Re: Comments of Iberdrola Renewables, Inc. regarding the Tule Wind Project Draft DEIR/DEIS- Modified Project Layout

Tule Wind, LLC, a wholly owned subsidiary of Iberdrola Renewables, Inc. (IRI), submits this letter to summarize proposed minor modifications to the Tule Wind Project since the project was submitted to you with IRI's Applicant Environmental Document (AED) in September of 2010. Submitted herewith is a modified project layout in GIS format and other information, such as recently completed surveys and technical studies that have been revised based upon the Tule Wind Modified Project Layout. Enclosed with this letter are specific suggested edits to the Draft Environmental Impact Report/Environmental Impact Statement (EIR/EIS) in "track changes" format to help facilitate incorporation of the minor changes resulting from the Modified Project Layout into the Final EIR/EIS as the applicant's proposed project. IRI submits this information to the Lead Agencies to supplement IRI's comments on the Draft EIR/EIS for the Tule Wind Project submitted under separate cover.

Figure A-3: Preliminary Underground Alignment Drawing 3 of 10

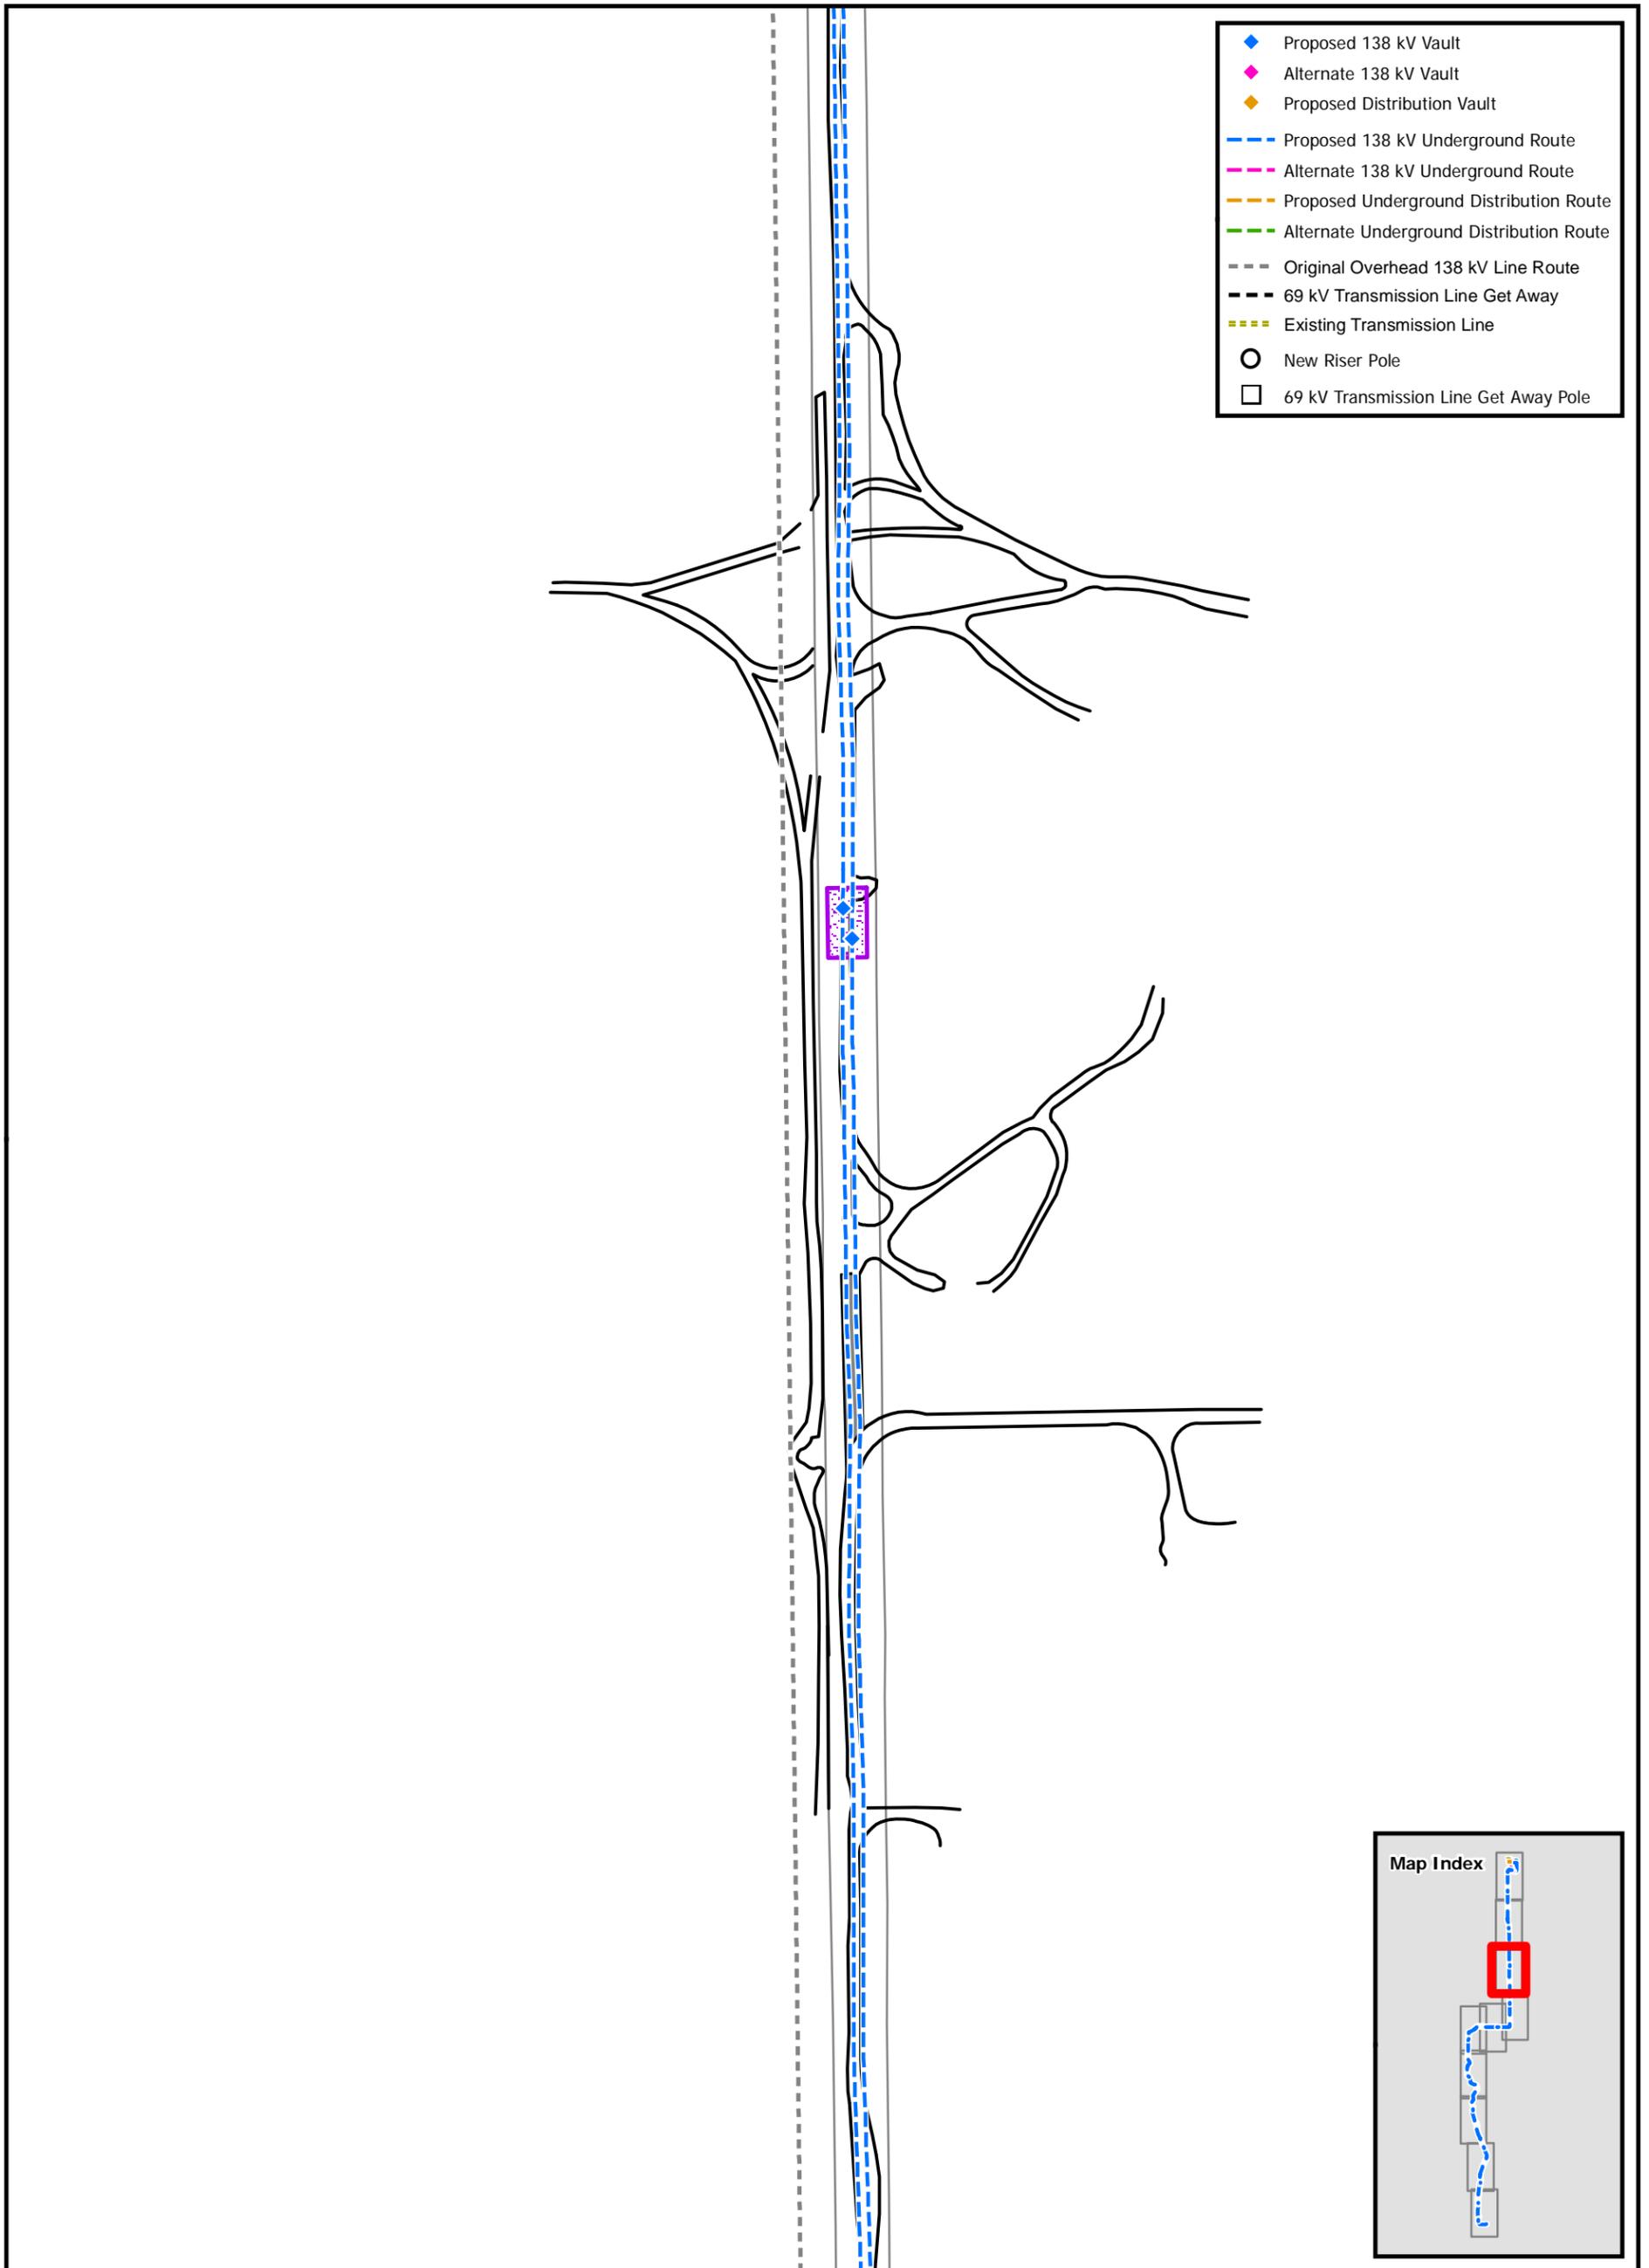
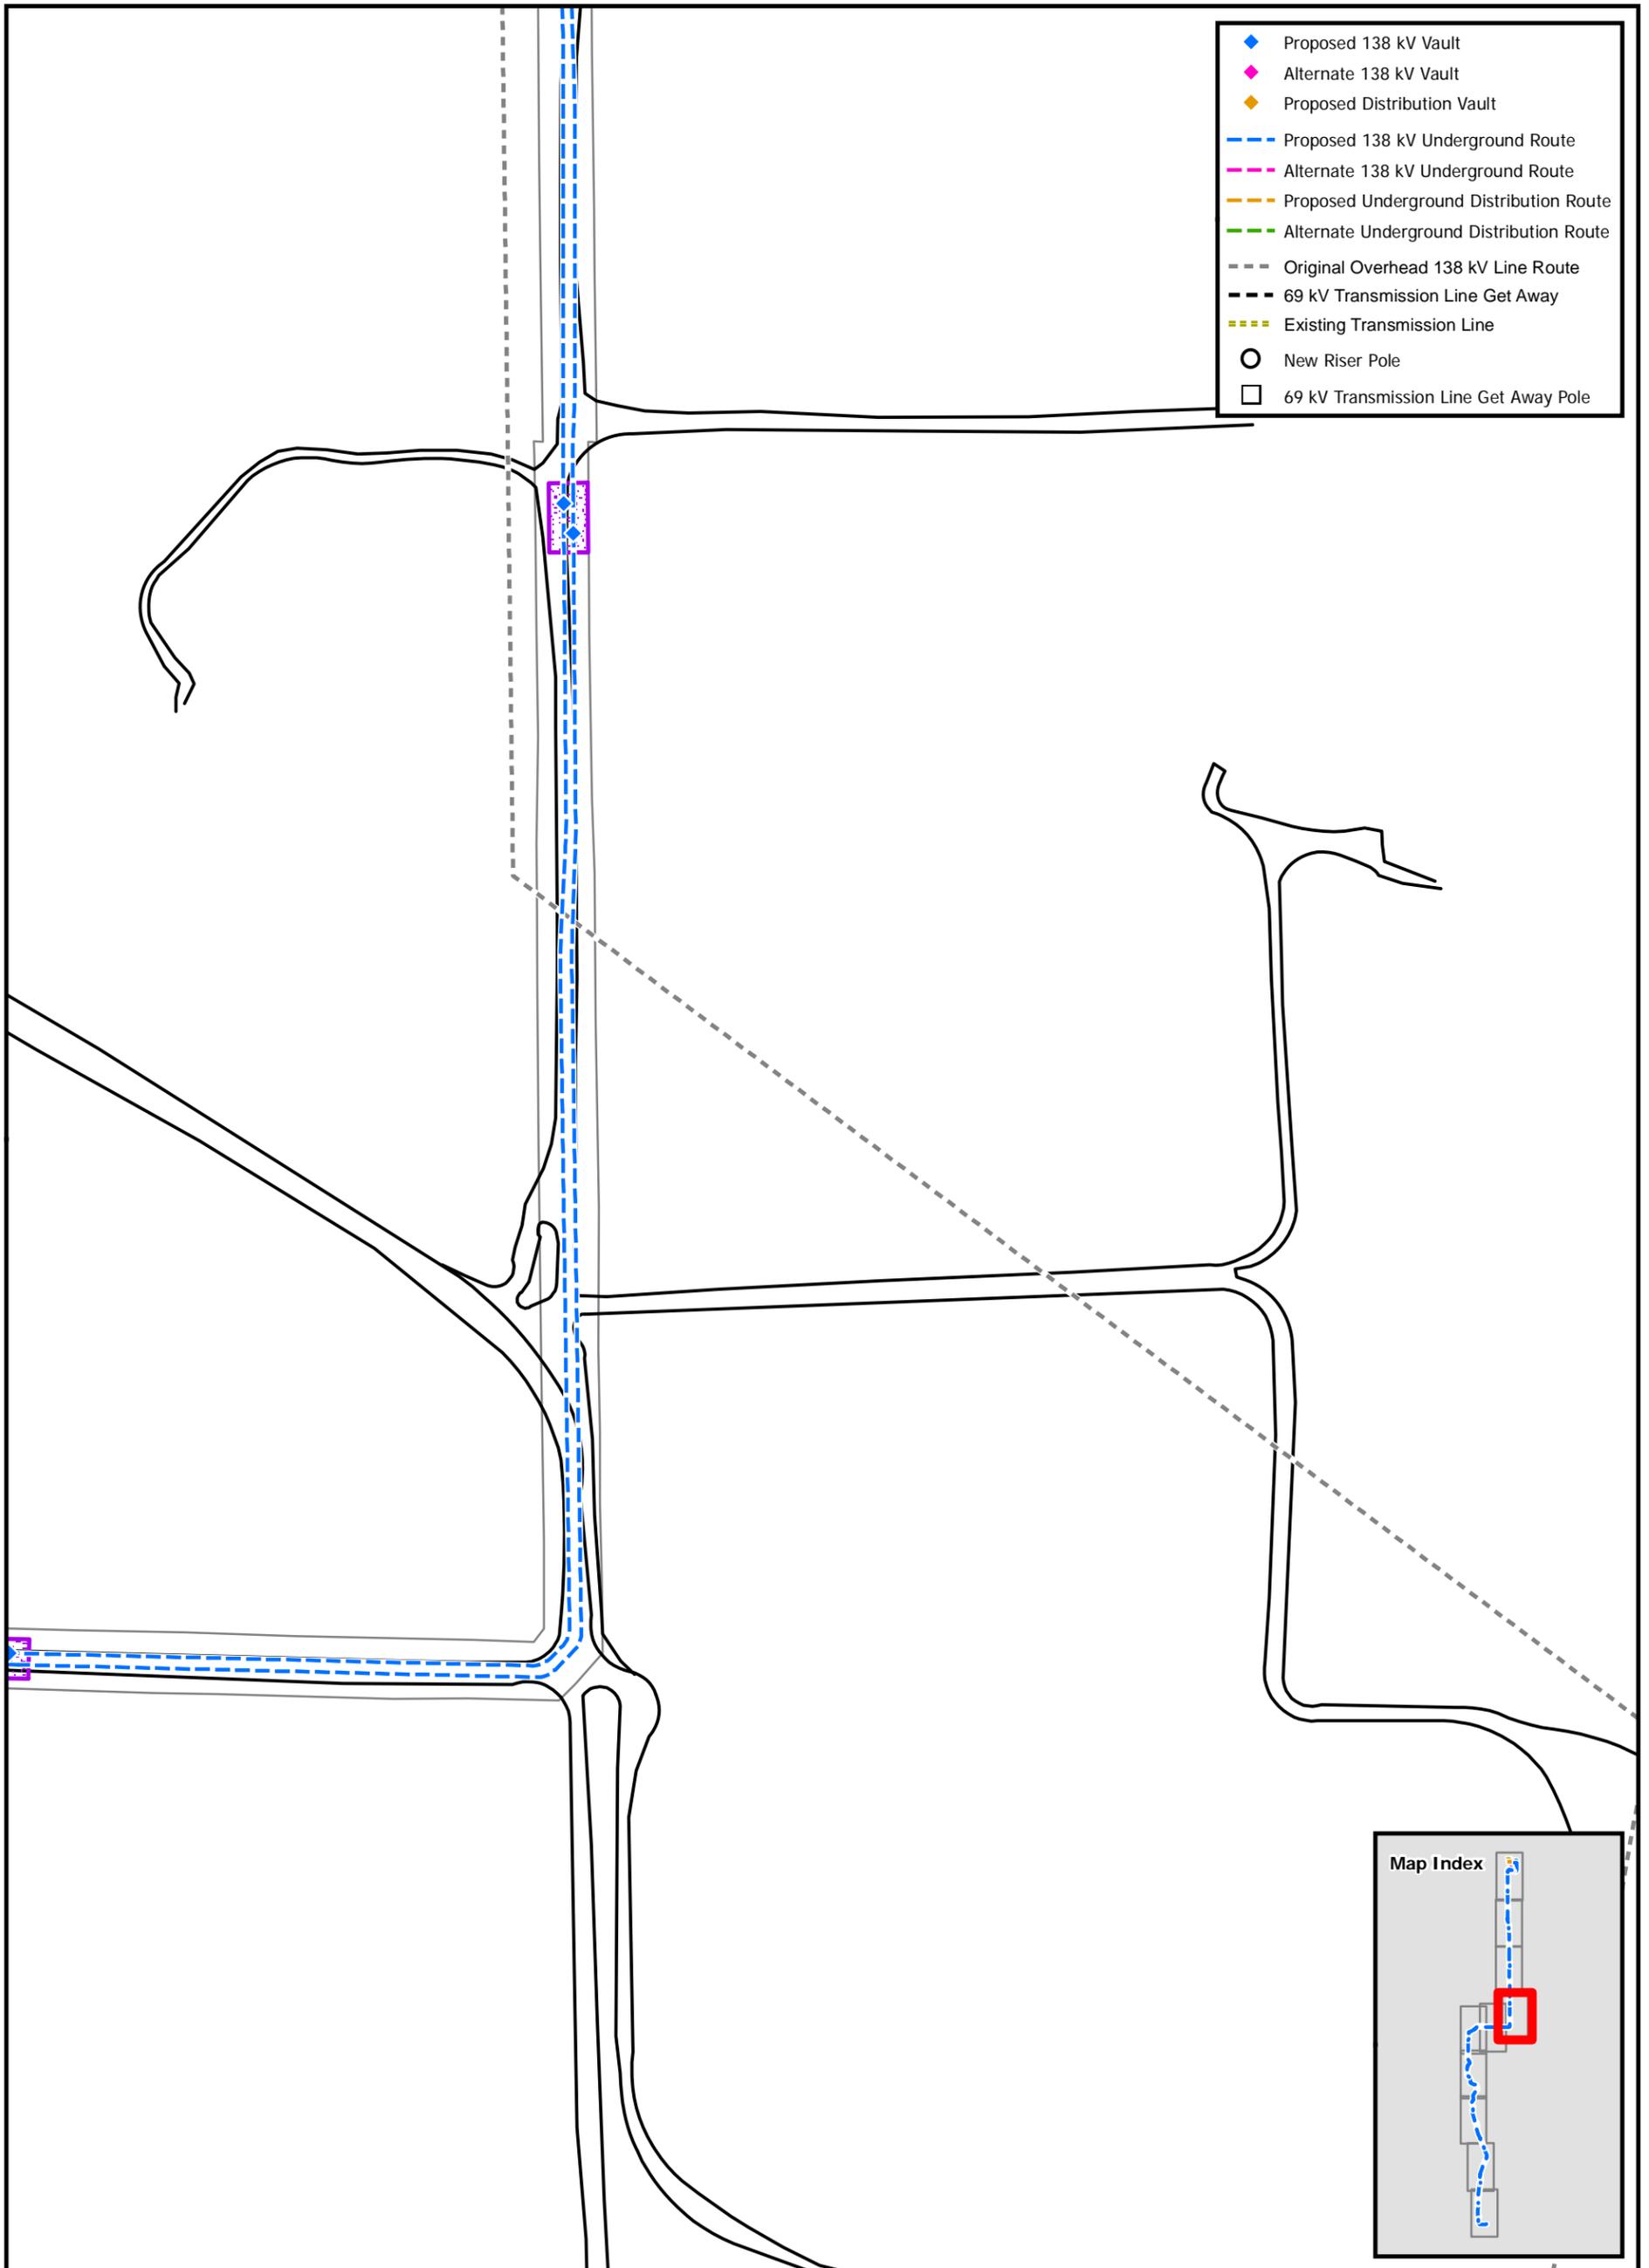
In order to assess the potential impacts to biological, cultural, and hydrological resources from the partial underground portion of the Project, field surveys of the area were conducted in February 2011. From the results of these surveys, SDG&E prepared a feasible preliminary design of the underground section of the Partial Underground Alternative, which is depicted in the attached Figure A-3: Preliminary Underground Alignment Drawing. Based on this preliminary design, the overhead portion of the 138 kV transmission line would transition to an underground configuration at two new riser poles located within the same permanent pole work area previously designed for steel pole 38. From these two new riser poles, two parallel duct banks separated by up to 20 feet would be installed typically within or directly adjacent to existing roads in the area. The duct banks would measure approximately 4.1 miles long and each would pass through approximately 11 vaults before terminating at the Boulevard Substation. The duct banks would be installed using the direct trenching method of construction in all but two locations. An approximately 690-foot-long segment would be installed using the horizontal directional drilling method to cross under a large jurisdictional feature and an approximately 280-foot-long segment would be installed using the jack-and-bore method to cross under an existing San Diego & Arizona Eastern railroad.

The impacts of the underground alignment were then determined based on a worst-case scenario (since there are two alternative routes into the substation as depicted in Figure A-3: Preliminary Underground Alignment Drawing that are substantially similar). As demonstrated in Table A-7: Preliminary Partial Underground Impacts, these impacts would not be substantial and would not therefore be significant.
